## PLANNING COMMISSION STAFF REPORT

<b>Originator</b> <b>Cary Teague</b> <b>Director of Planning</b>	<b>Meeting Date</b> <b>January 28, 2015</b>	<b>Agenda #</b> <b>VI.B.</b>
--	--	---------------------------------

Donnay Homes are proposing to tear down the existing double dwelling unit at 3621 and 3625 54<sup>th</sup> Street West, and build a new one. (See property location on pages A1–A3.) To accommodate the request, the following is requested:

# STORMWATER AND EROSION CONTROL PLAN

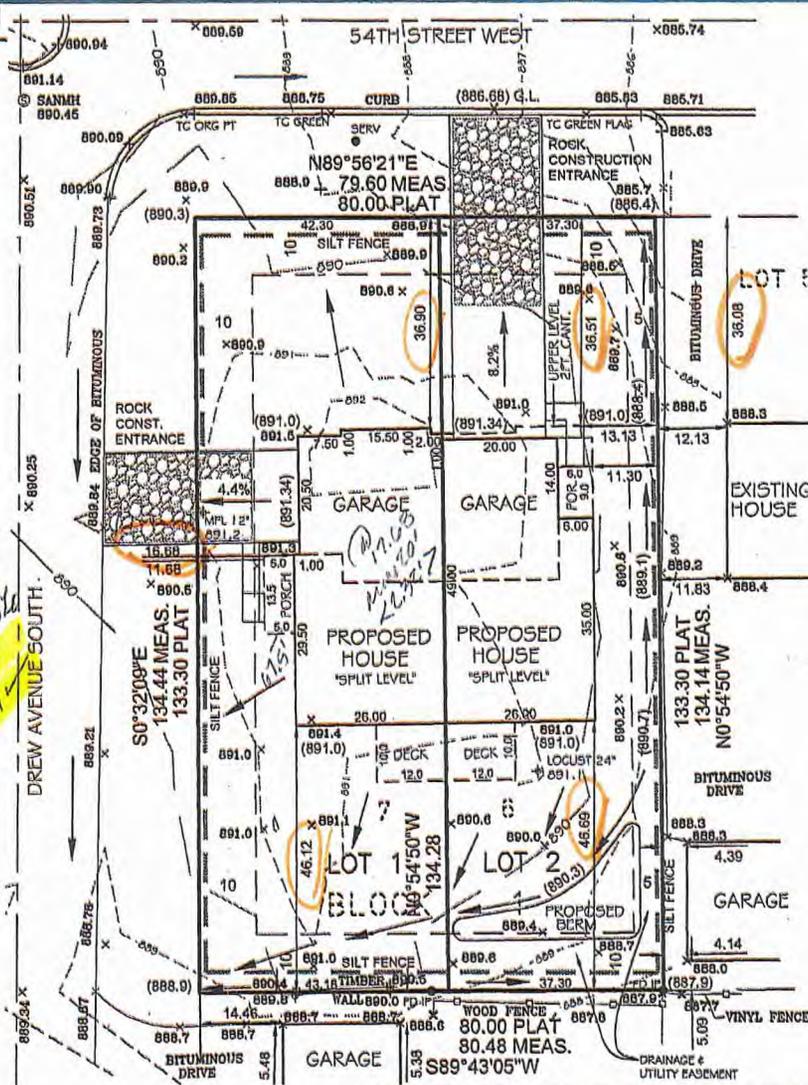
Engineering has only minor concerns with the plans as submitted. The proposed plan appears to be the demolition and reconstruction of an existing two-family dwelling. The proposed storm water management plan directs existing and additional drainage to the streets and away from nearby private property. The applicant will need to provide separate sanitary and water services for each address. The applicant will also need to apply for separate curb cut permits for each address.

The proposed grading plans direct the drainage away from nearby private property and to the streets. This is accomplished via swales and a proposed berm. This condition will be an improvement for the neighboring properties over existing conditions. The storm sewer utility has capacity for the additional runoff and will not be affected.

Request Variance Area

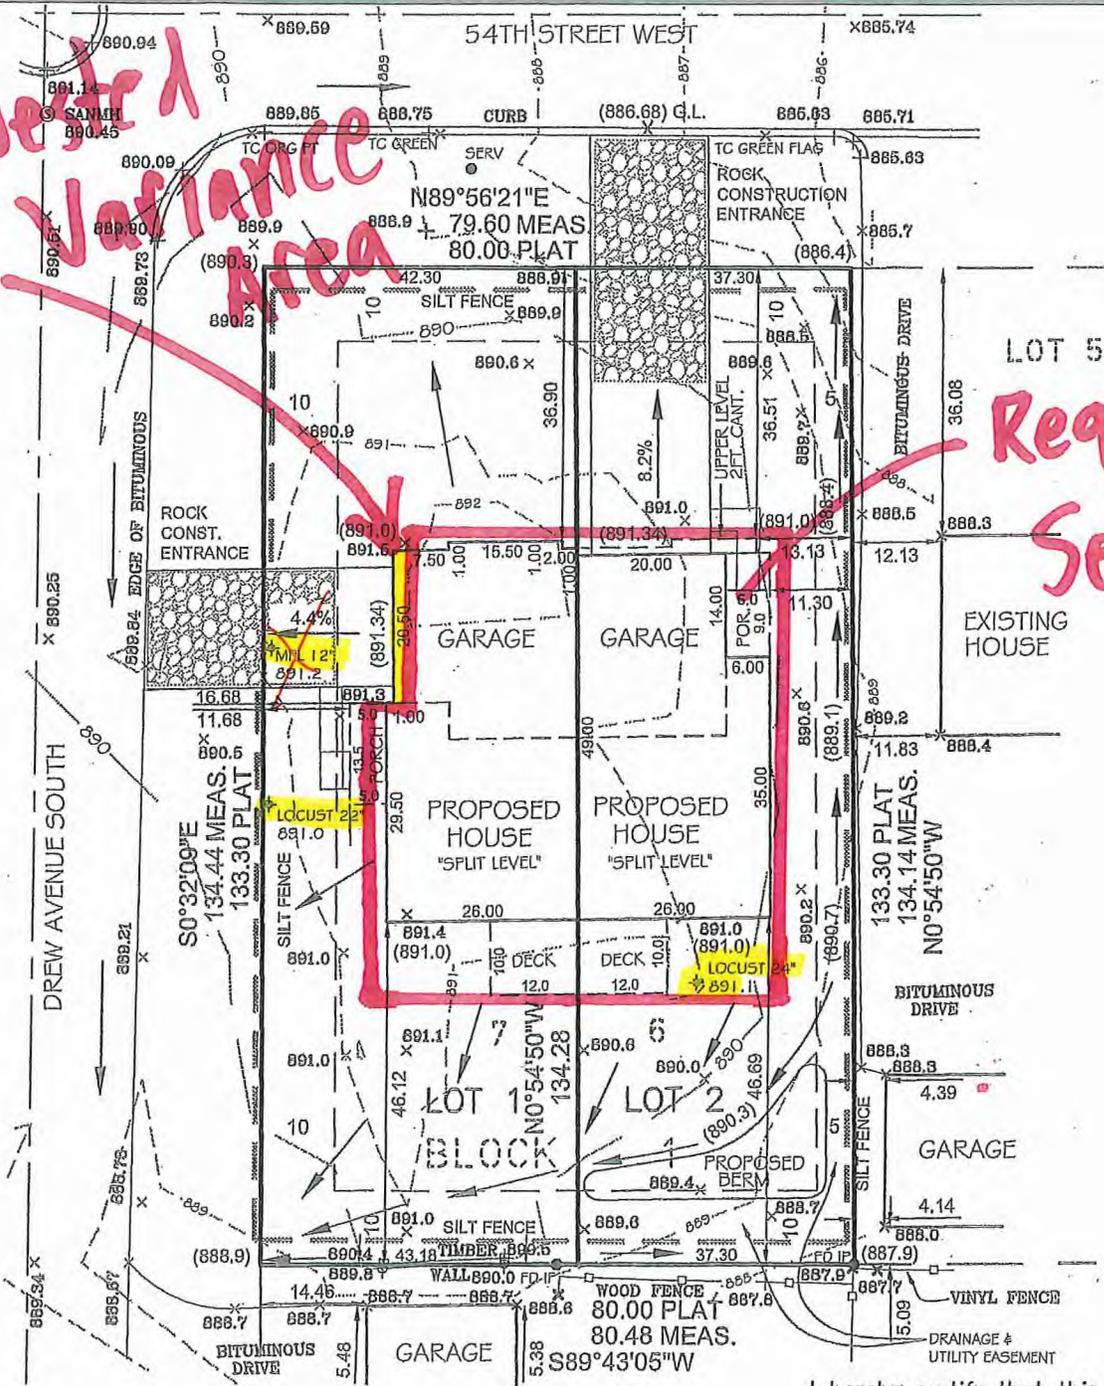
1. A two-foot side street setback variance from 20 feet to 18 feet, so the garage adjacent to Drew Avenue has its opening facing Drew, rather than 54<sup>th</sup> Street;
2. A lot area variance from 15,000 square feet to 10,748 square feet and lot width variance from 90 to 80 feet to built the new structure. The lot size and width are existing conditions, but would still require a variance; and
3. A lot division to create a party-wall division of the new structure. The new structure would be built with a fire rated wall separating the two units. This would provide protection for each unit, should there be a fire on the other side.

Staff believes the proposed variance is reasonable. The lot size and narrow width of the lot are the practical difficulties that limit the size of the building pad for a double dwelling unit. The applicant could relocate the garage opening for the garage to 54<sup>th</sup> Street, and all required setbacks would be met. However, in doing so, there would be more building articulation along the side wall, as each side of the home facing the street would appear to be a single family home. (See page A9.) This would be more consistent with the neighborhood given the single family homes that exist across the street from each garage door opening. (See pages A2, A3, and A10.)
